**MINUTES
CITY OF UKIAH PLANNING COMMISSION
February 14, 2007**

9B. Major Site Development Permit No. 06-19 & Minor Subdivision Map No. 06-18, as submitted by Ruff & Associates Rite-Aid Corporation, to allow the construction of a 17,026 square foot drugstore to replace the existing Rite-Aid drugstore, which would be demolished once the new store is open for business, and divide the 2.5-acre site into two lots with gross areas of 71,026 square feet and 38,001 square feet. The project is located at 680 South State Street (APN 002-301-43), on the northwest corner of its intersection with West Gobbi Street.

STAFF REPORT TO THE PLANNING COMMISSION

SOUTH ELEVATION

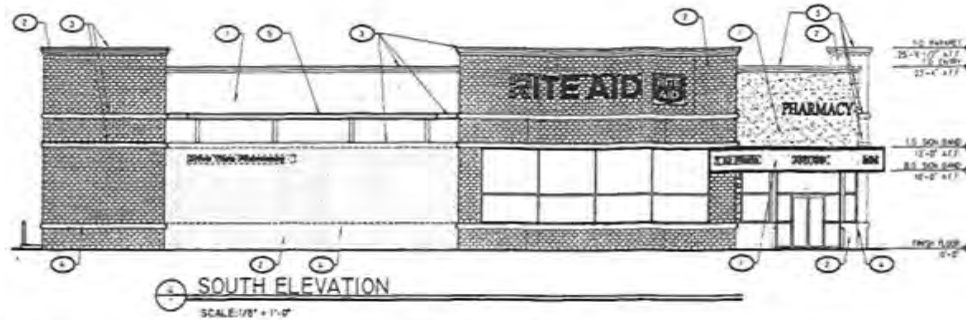
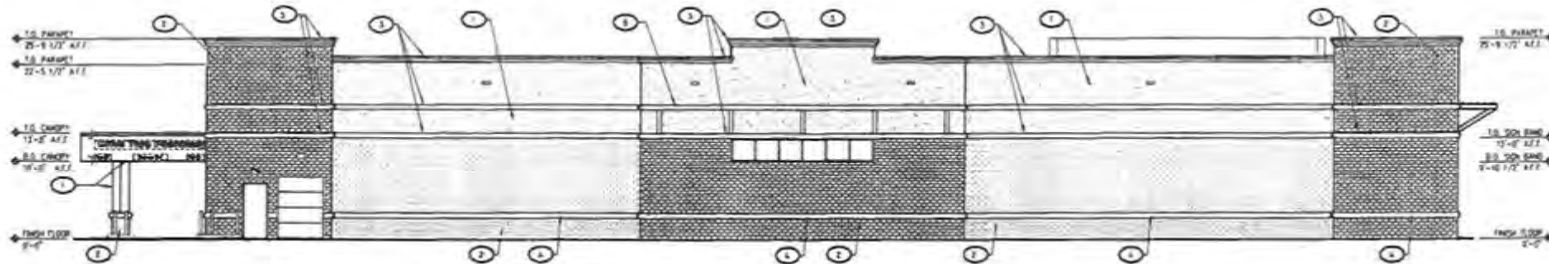
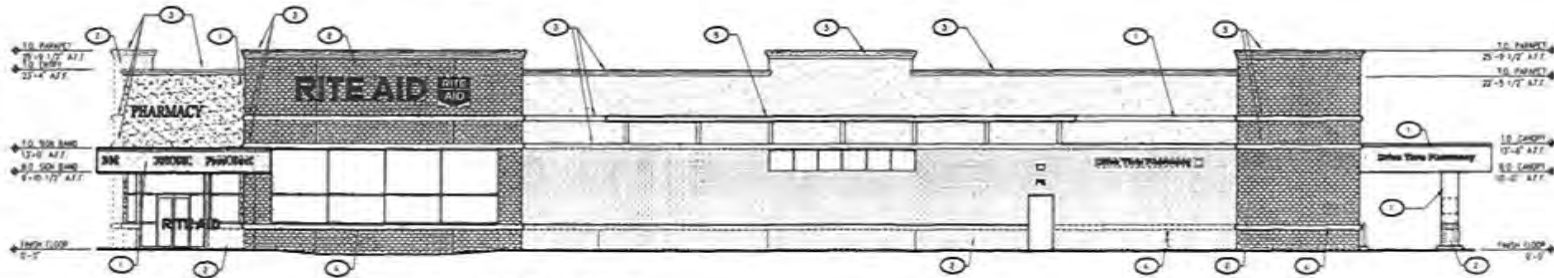
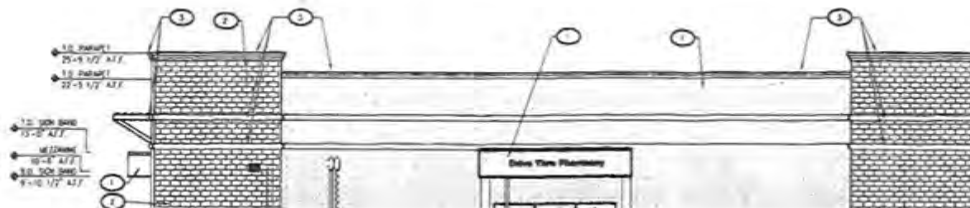
Commissioner Molgaard inquired whether thought has been given to energy efficiency design and noted the plain mass walls do not have windows or some type of treatment to break up the mass. Additional windows would allow for more light and less consumption of energy and associated costs, as well as provide for a more aesthetic pleasing appearance.

- **Chair Pruden** questioned how much more fenestration and/or project revisions can be requested to be in substantial compliance without the applicants having to go back through the discretionary review process.

Commissioner Mulheren stated the applicants have done a nice job redesigning the project, as recommended by the Planning Commission that reviewed the initial project. He supports if windows are added to a particular elevation, for instance, the applicants/architect should be allowed to exercise discretion as to the quantity and placement.

Jason Brennen referred to the site plans and reiterated a good portion of the parking is in the rear of the proposed building. The vehicle circulation is through the rear of the building and away from the building front although access is from the front entrance off the street. The building would have two front entrances to assist with effective circulation on-site. Pedestrian safety and accessibility were a major concern where considerable design efforts were made in this regard. As far as increasing the number of windows, the Rite Aid corporation has limitations as to the number of windows it can incorporate relative to window display and merchandise. The applicants desire to provide as much "green" on the site as possible, as well as provide for adequate shade with the trellises and awnings. The windows were designed as large as possible to create that "friendly" atmosphere.

Associate Planner Lohse stated in order to avoid going back through the discretionary review process, the project should likely be conditioned such that the fenestration is done to a suitable model, and allow staff to verify this. Otherwise, the project would likely have to be deferred depending upon how much fenestration is being requested.

Jason Brennen referred to the building elevation relative to the site plan A-2.1, and identified which elevations have windows proposed, including the design techniques.
